November 27, 2013

RFB NO. 313086 - ADDENDUM NO. 4

ARCTIC ANIMAL EXHIBIT AND CONCESSIONS

ST1.2

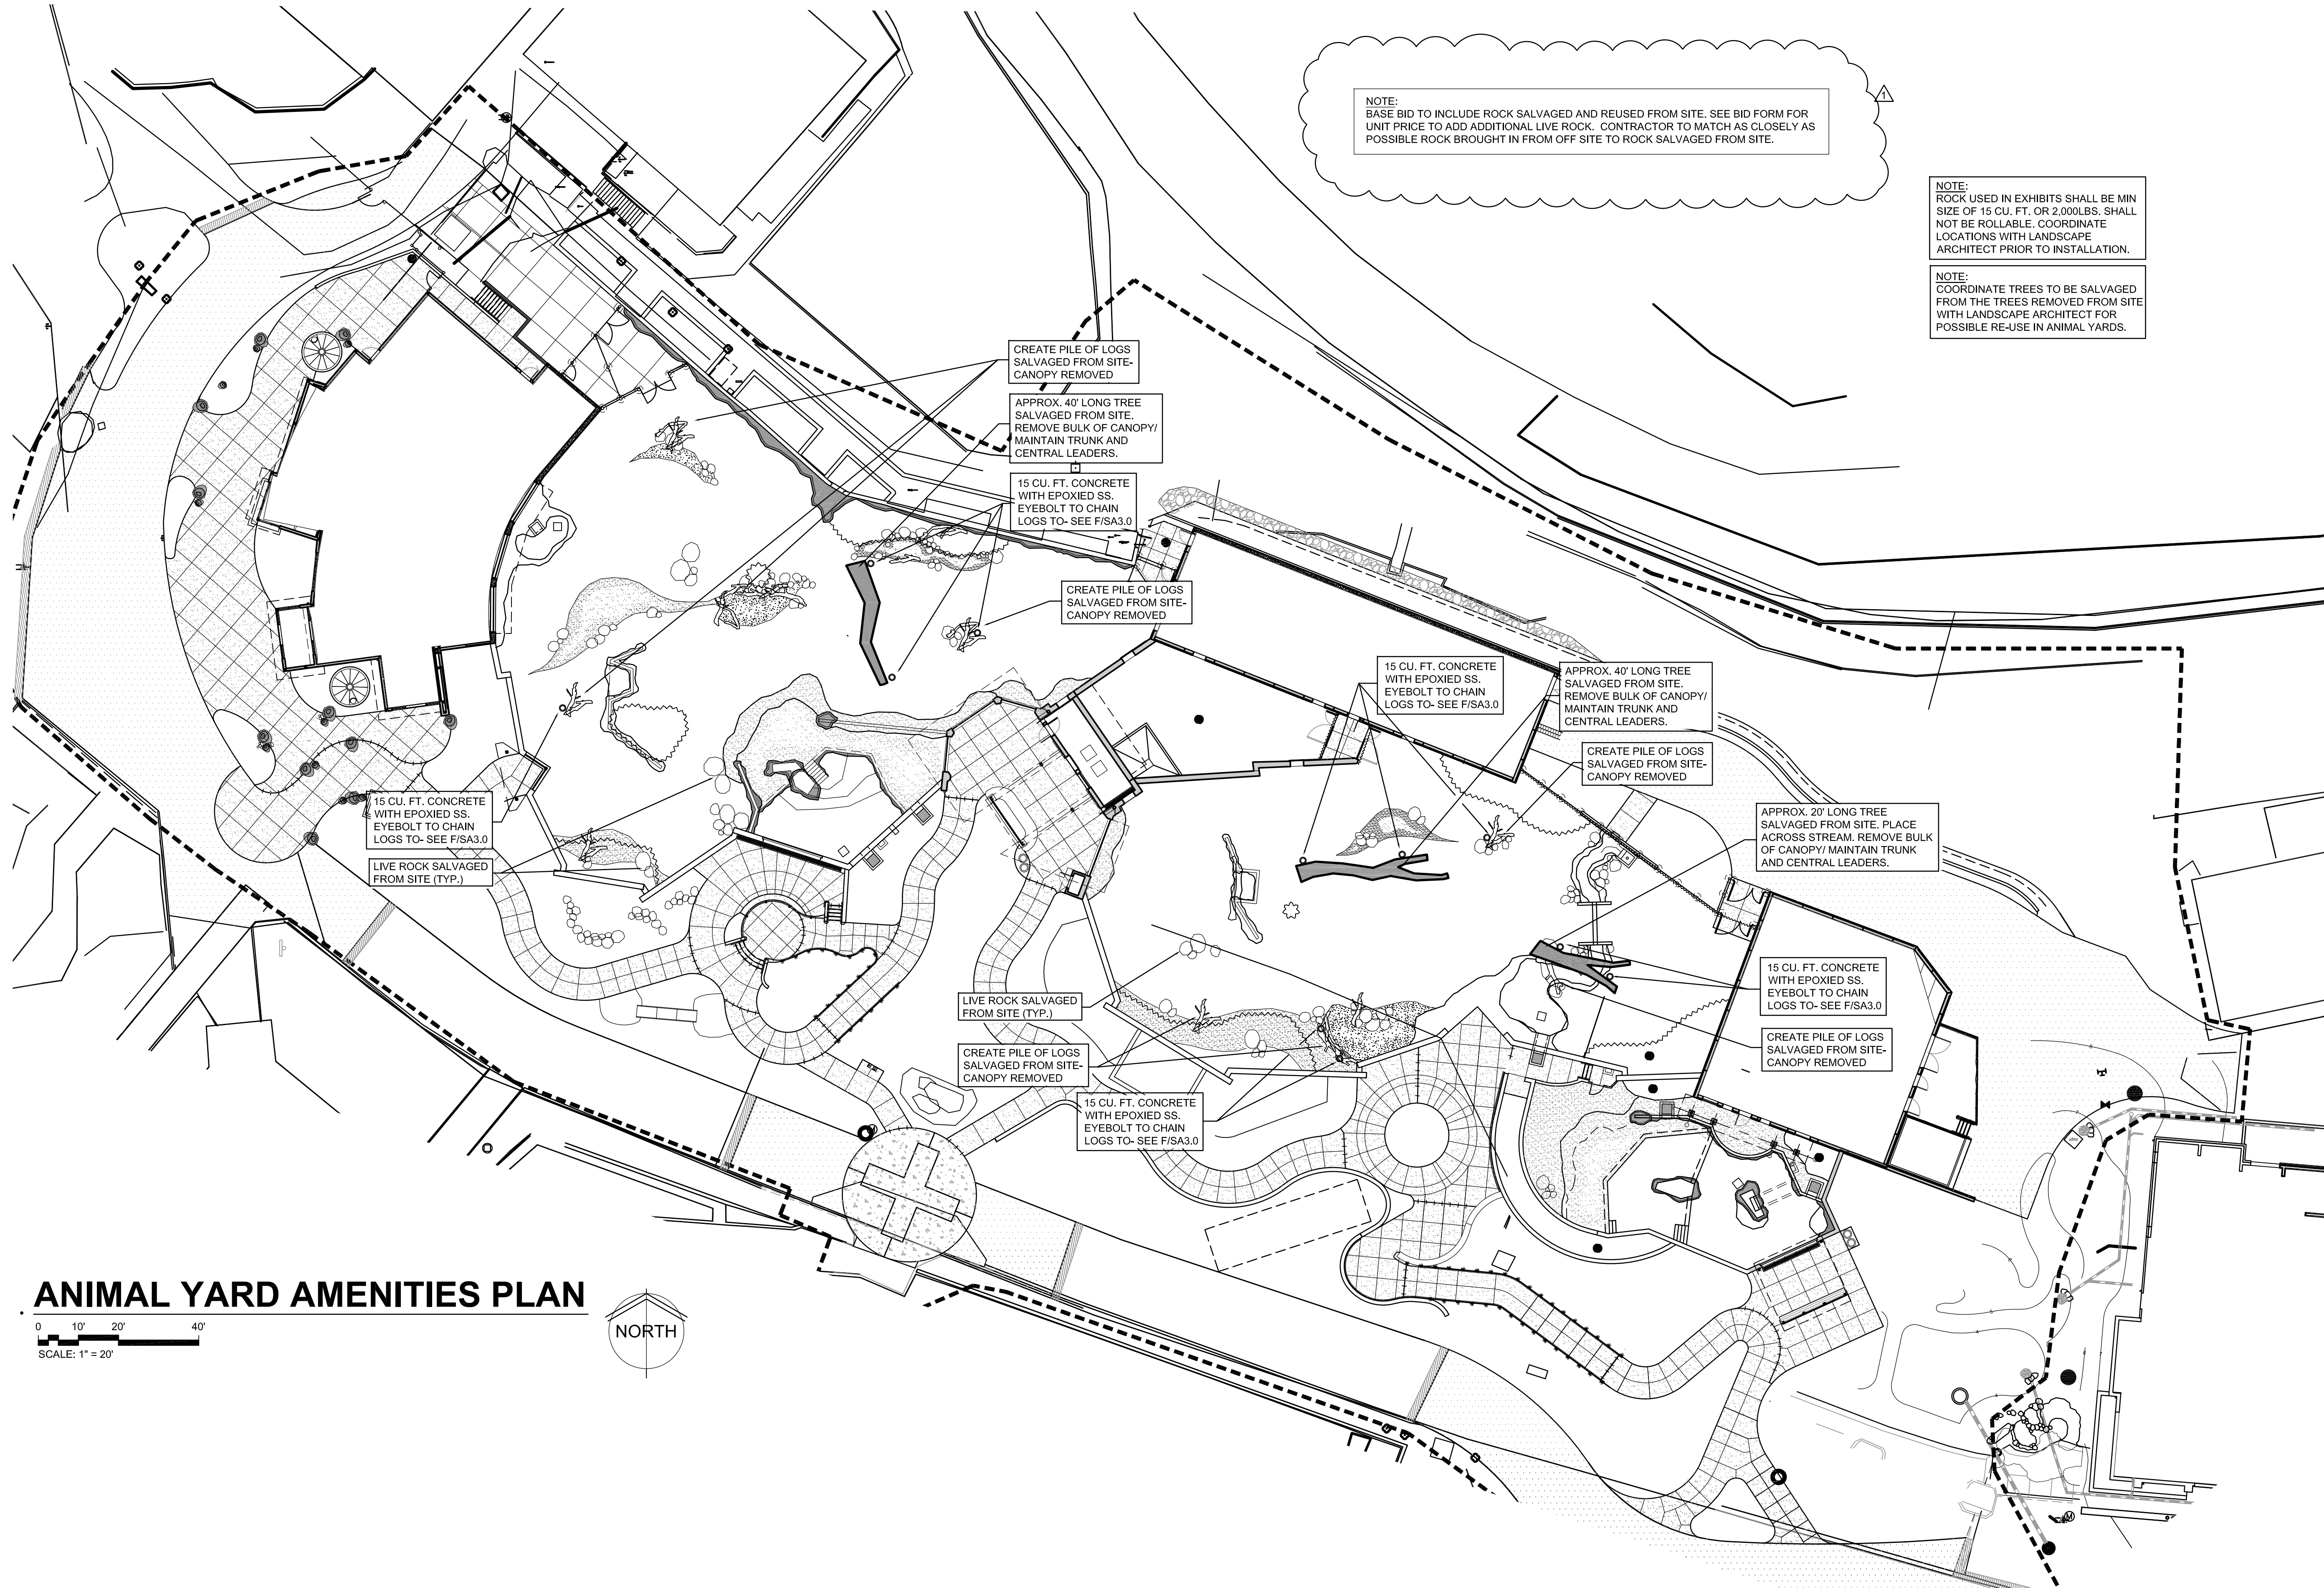
- Updated references to themework sections/ elevations
- Eliminated the 6th (last) themework type from the legend
